PENTON RESIDENCE
23160 LOWE DAVIS RD
RENOVATION/ADDITION PLANS
COVINGTON, LA.

REVISION DATES:		
No.	DATE	PURPOSE
1	5-24-22	REVIEW COMMENTS ADDRESS

BORDER ARCHITECTS, INC.
A PROFESSIONAL CORPORATION
67159 Industry Lane, Suite C.
Covington, Louisiana 70433
(TEL) 985-892-6112 (FAX) 985-892-6119

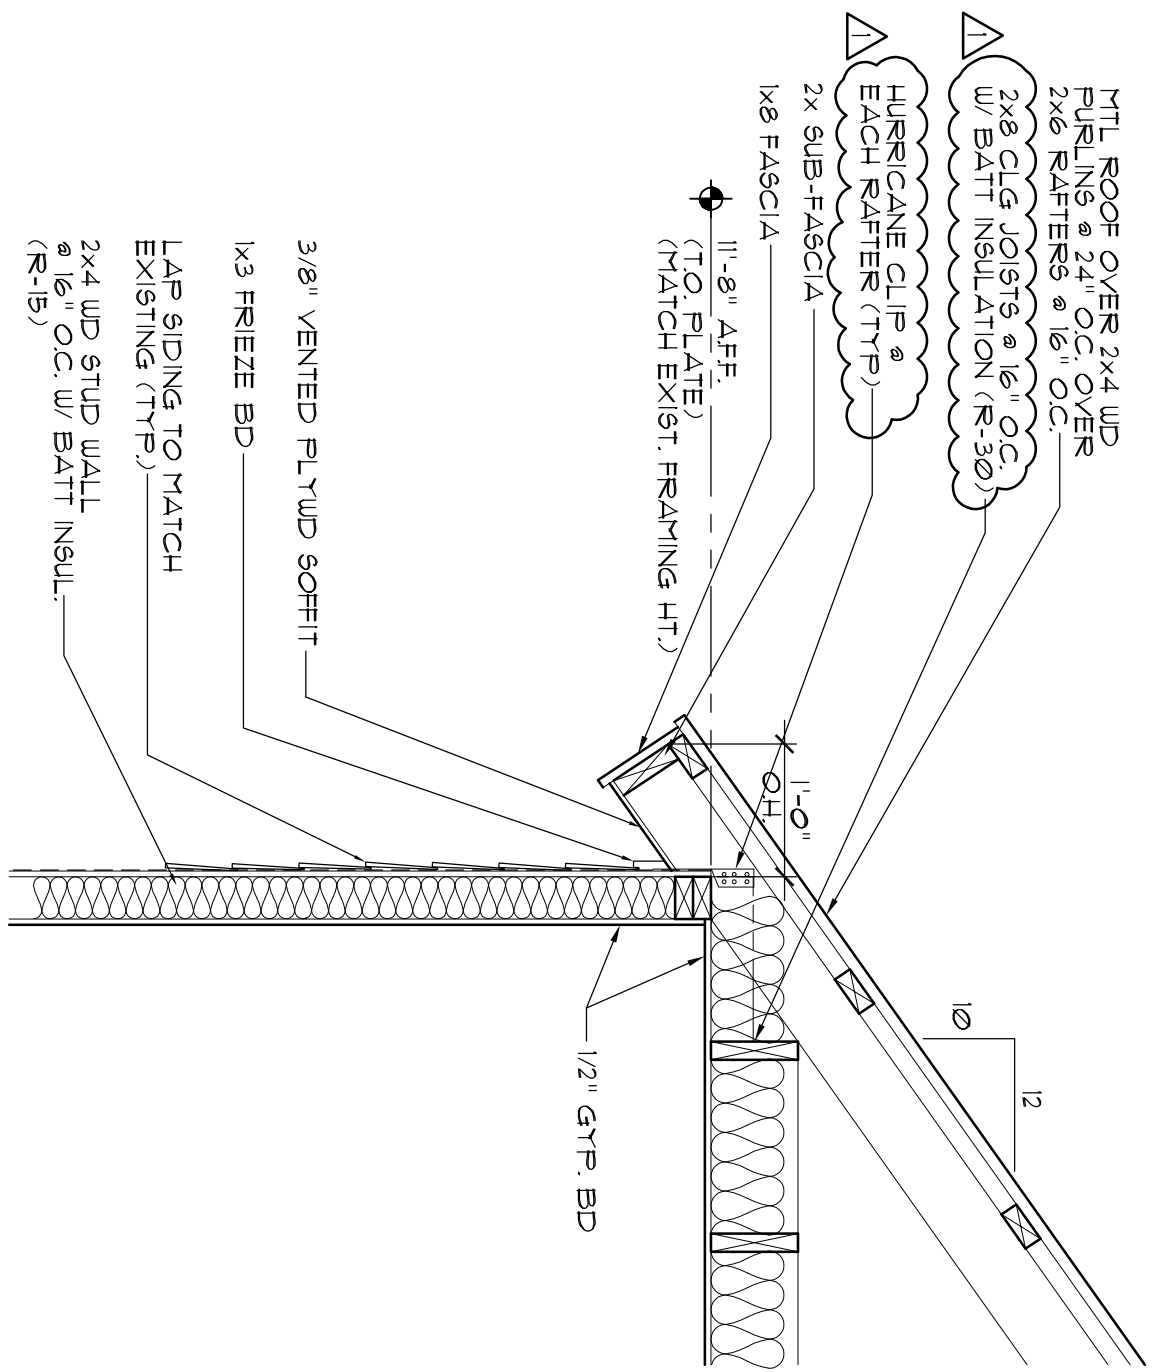
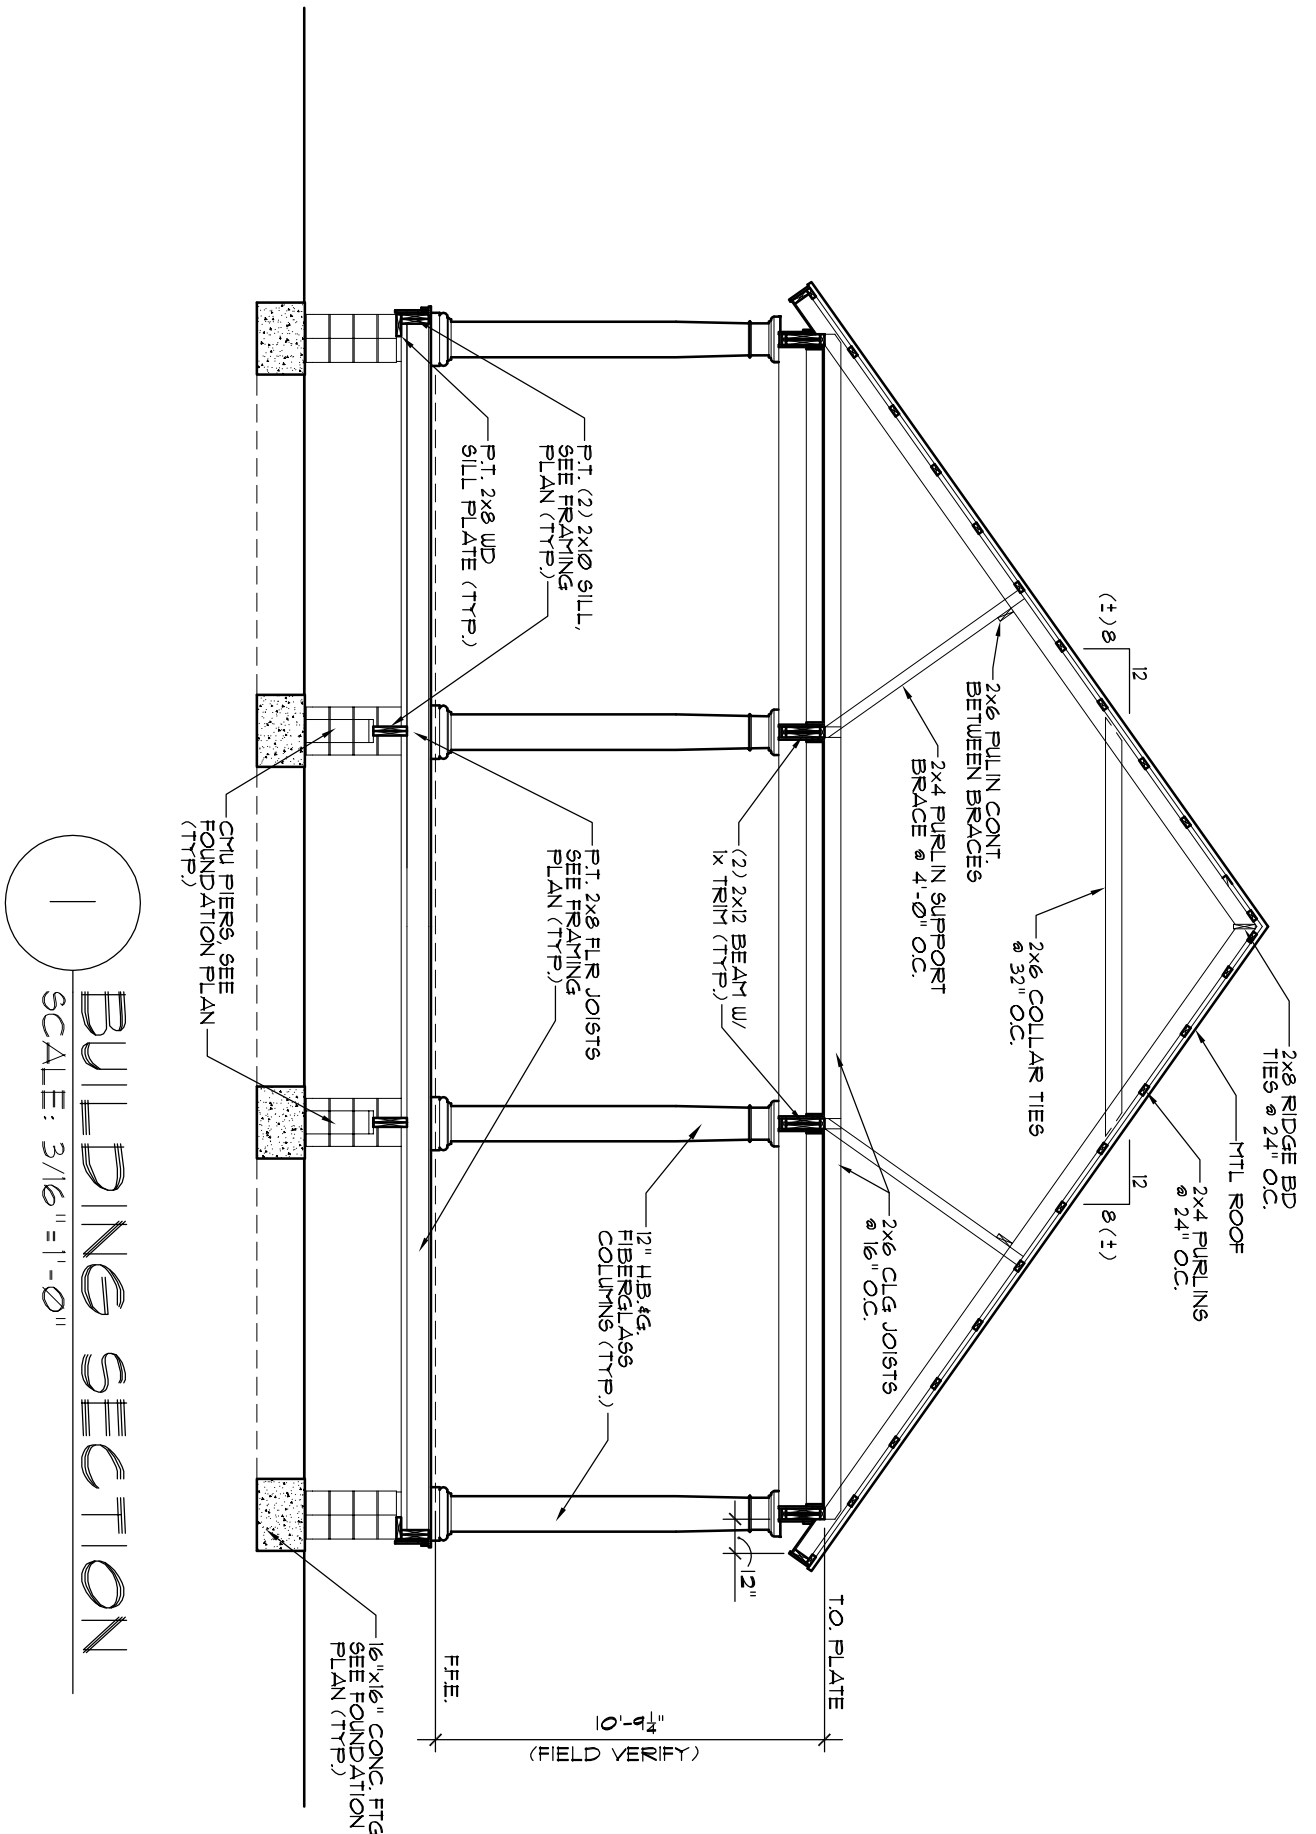
CEILING INSULATION CHANGED TO R-30.
R-13 INSULATION ADDED TO FLOORS.
JOIST HANGERS & STRAPS ADDED.

SHEET:
A401
OF -

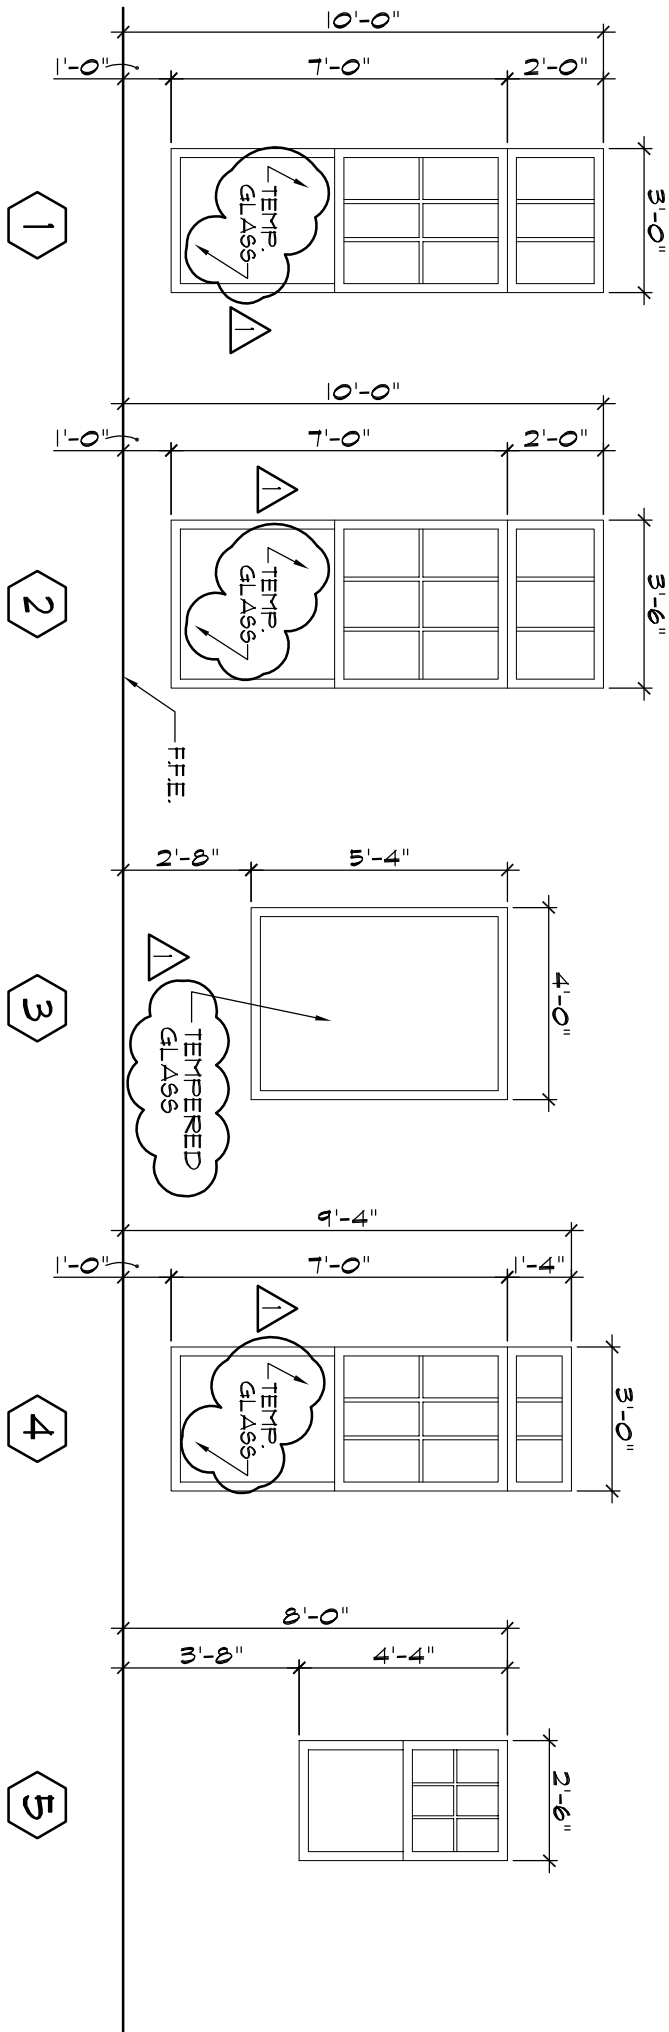
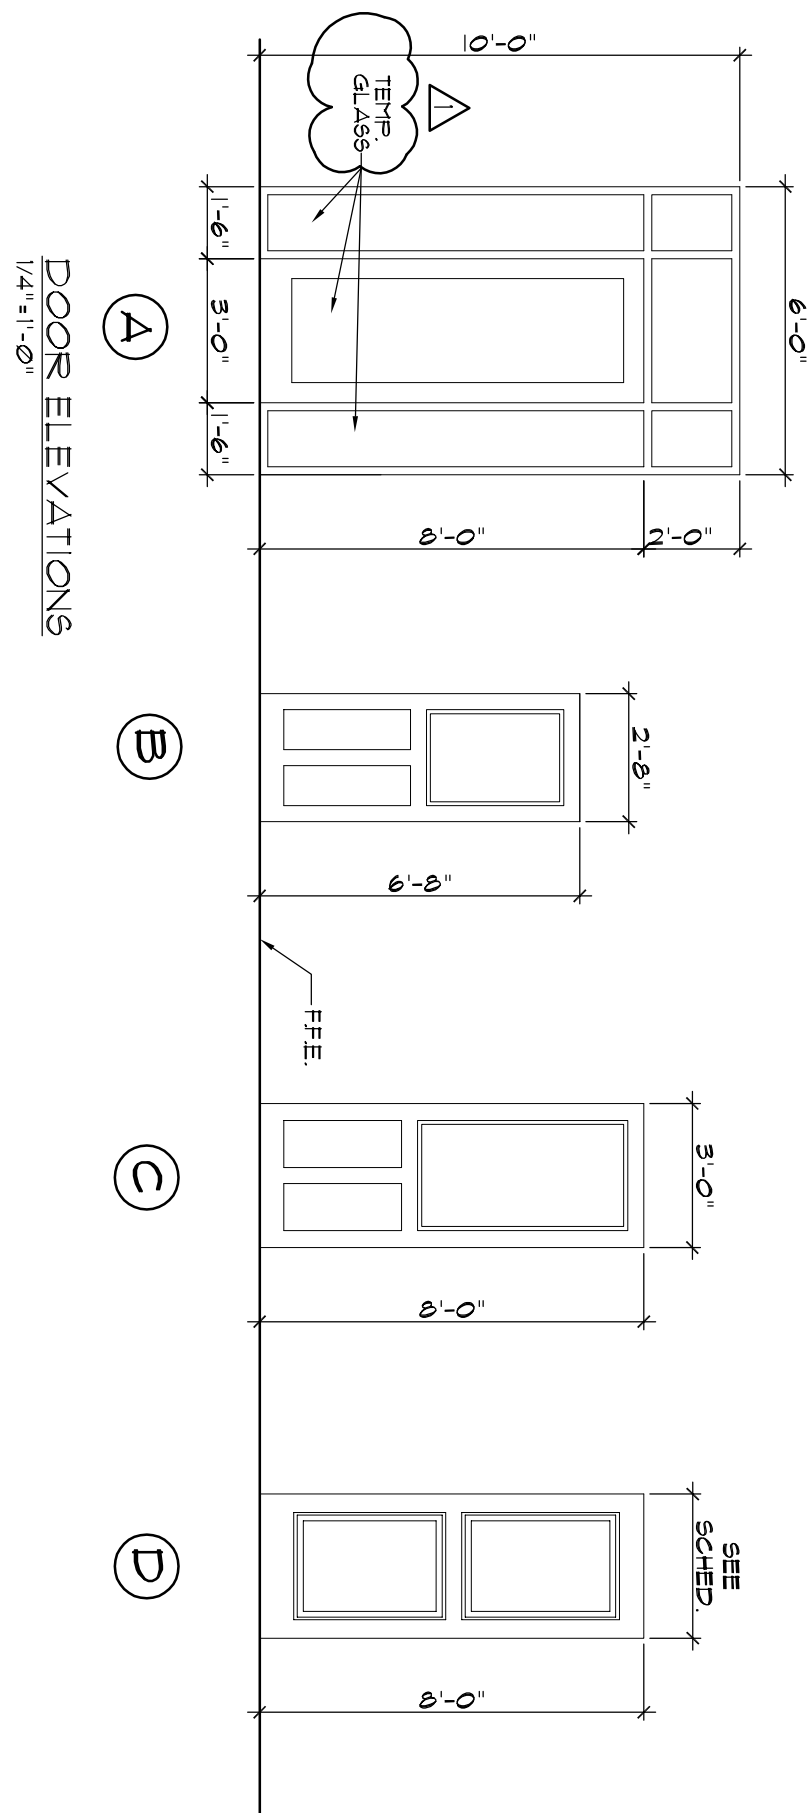
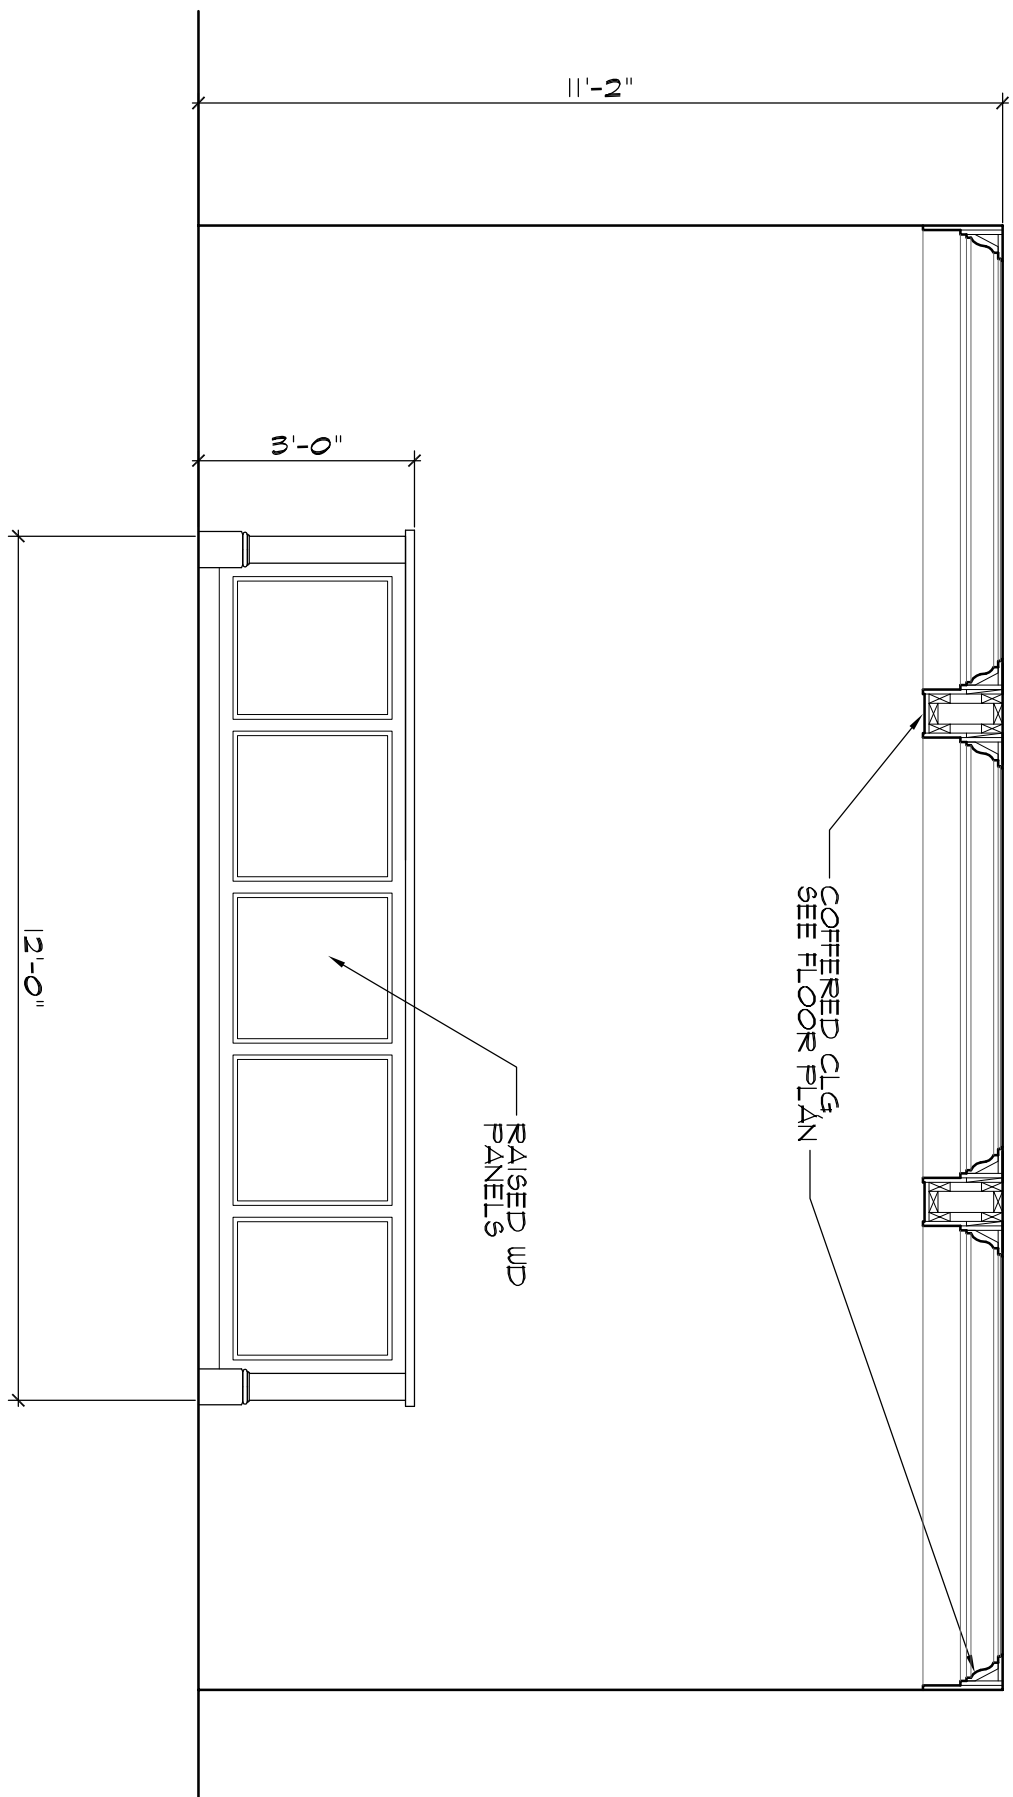
TEMPERED GLASS ADDED.
